FORM APPROVED
OMB NO 1004-0135
Expires July 31, 2010**SUNDRY NOTICES AND REPORTS ON WELLS**
Do not use this form for proposals to drill or to re-enter an abandoned well. Use form 3160-3 (APD) for such proposals.**SUBMIT IN TRIPLICATE - Other instructions on reverse side.**

| 1. Type of Well <input checked="" type="checkbox"/> Oil Well <input type="checkbox"/> Gas Well <input type="checkbox"/> Other | | 8. Well Name and No SAUNDERS 10 |

RECOMPLETION TO SEVEN RIVERS

**Saunders 10
30-015-21924
Alamo Permian Resources LLC
January 31, 2012
Conditions of Approval**

ALAMO PERMIAN RESOURCES, LLC
WELLBORE DIAGRAM

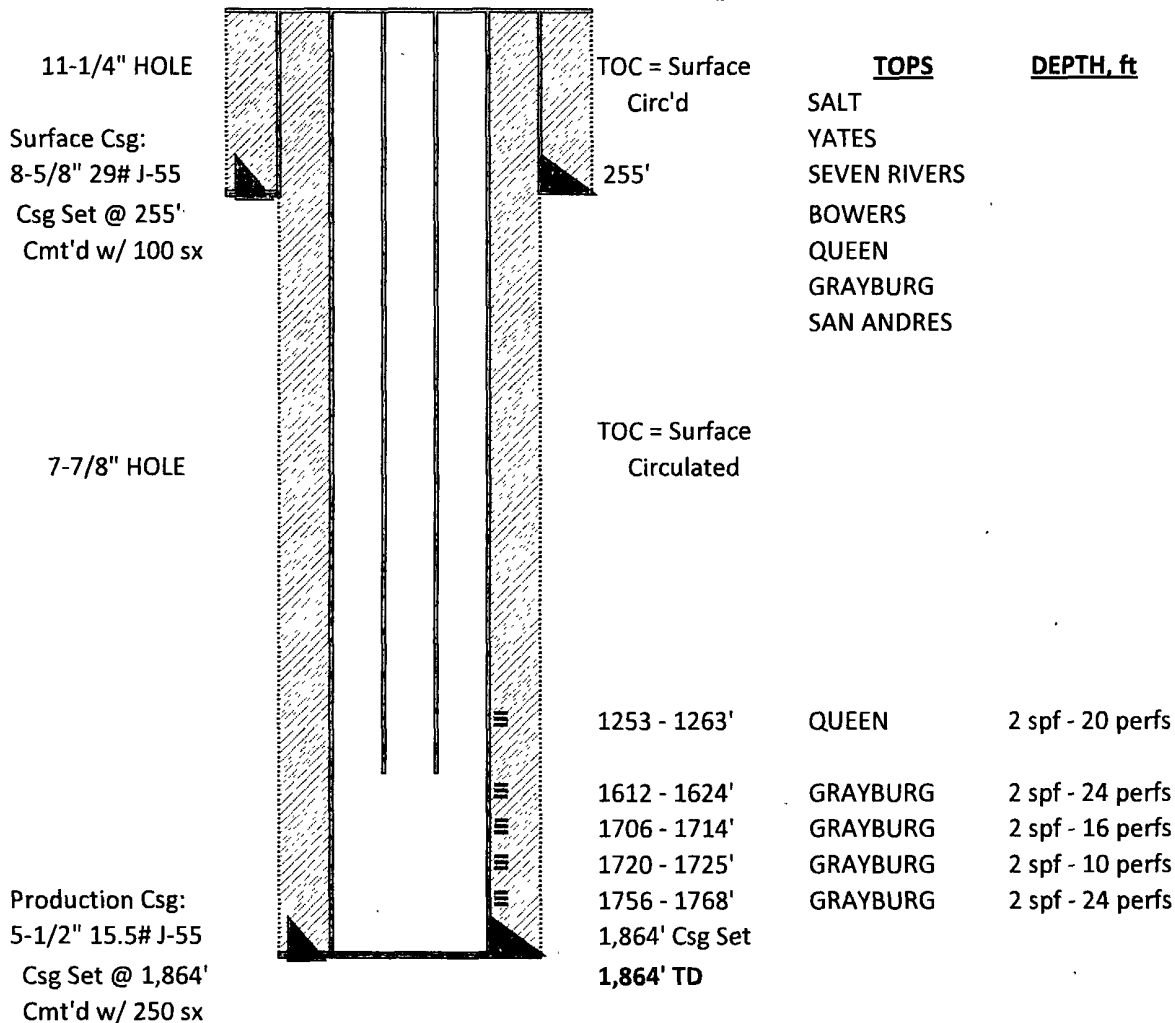
- 6. Operator shall submit copy of casing inspection/caliper/CBL to BLM.**
- 7. CIBP in 4-1/2" casing shall be set at 1,150' with 35' of Class C cement bailed on top of CIBP. Tag cement at 1,115' or shallower. Tag required due to bailing inconsistencies.**
